RE: Bluewater Campground
IWWC #2021-12
CLA-5918R

Following please find our review of your comments, dated January 12, 2022, for the above-mentioned project. Our responses are included in **bold**.

Perc Test # 1

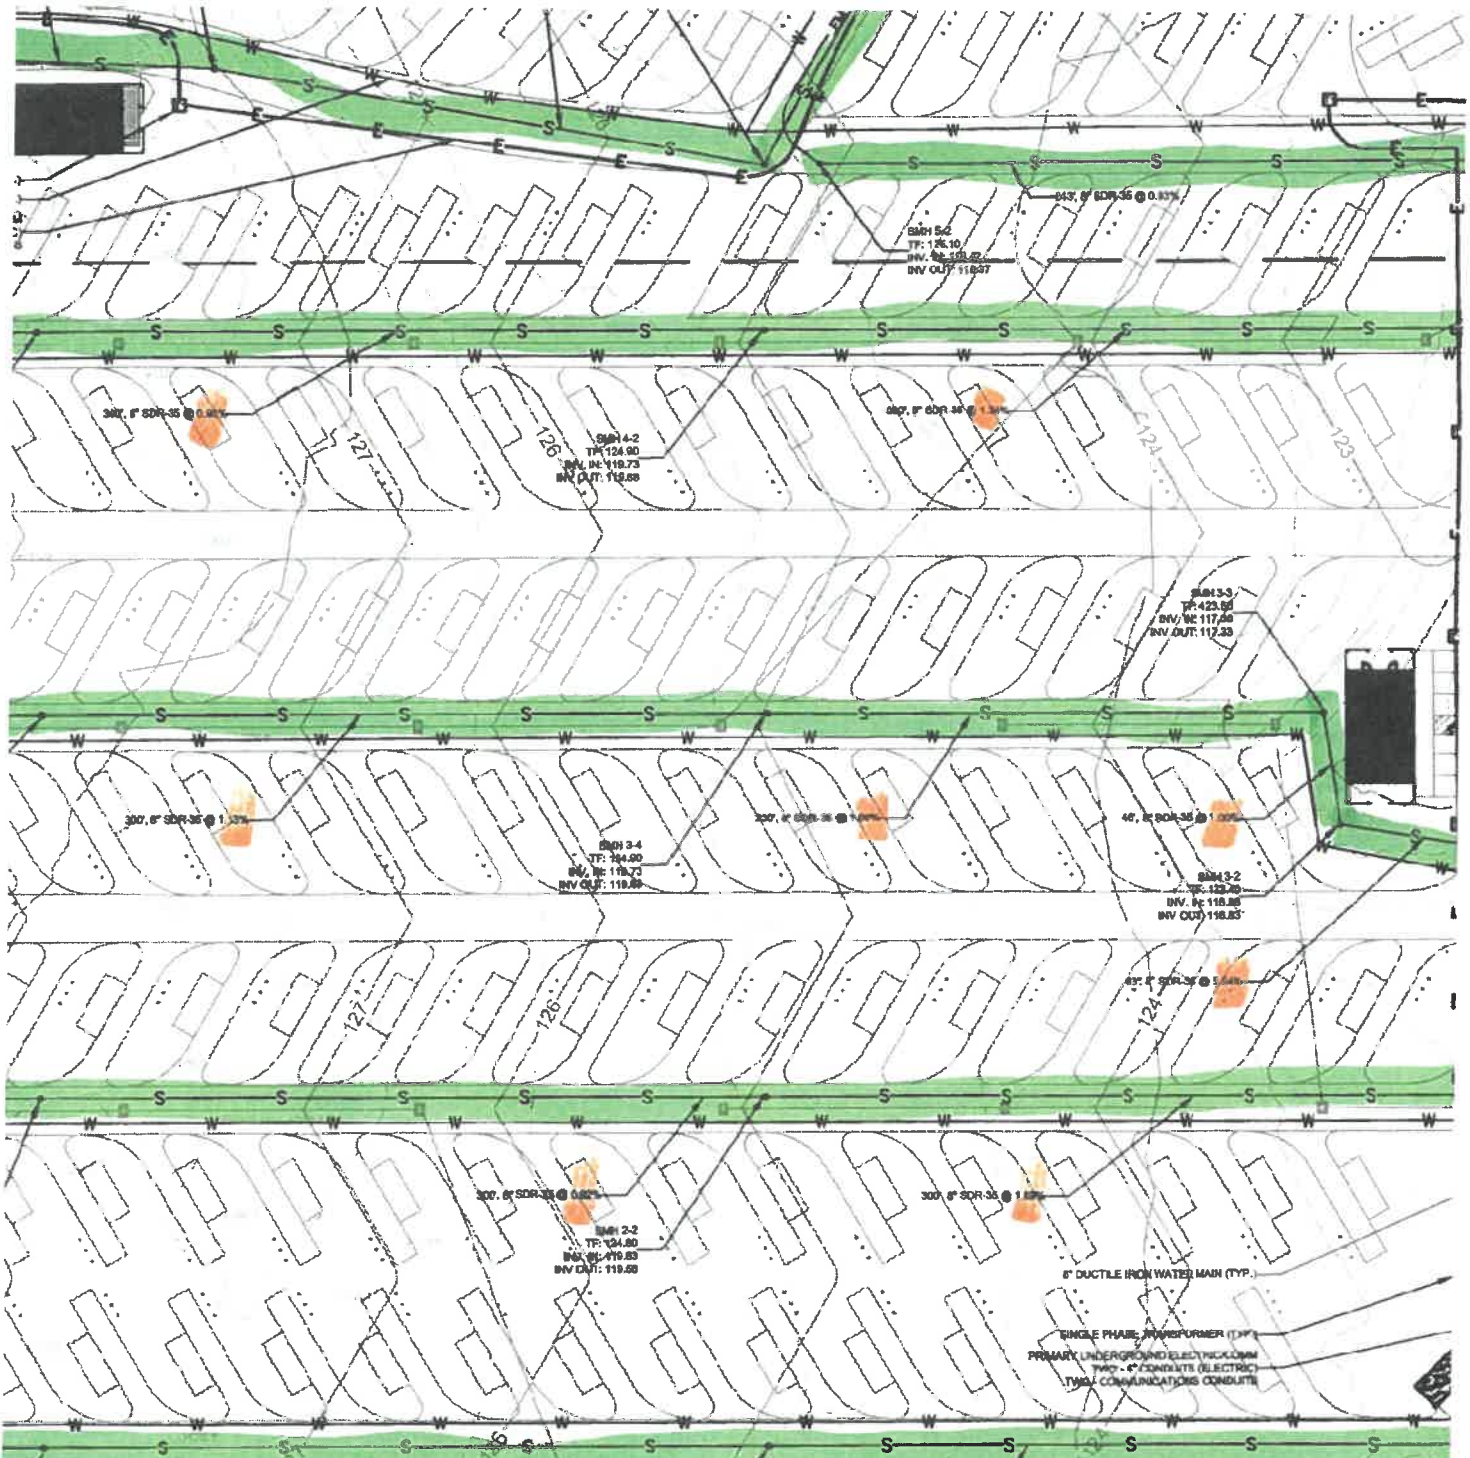
1. Detention Pond #2 is designed for 100% infiltration, permeability testing must be done in the pond area. A test hole located at the proposed pond was performed in mid August and is at the extreme end of the pond. If testing is delayed to the time of installation, the Town must be involved.

Response: On January 19, 2022, Benesch performed two (2) perc tests in the area of Detention Pond #2. The results indicated a percolation rate of approximately 12 inches per hour. Backup of these tests is provided to this letter.
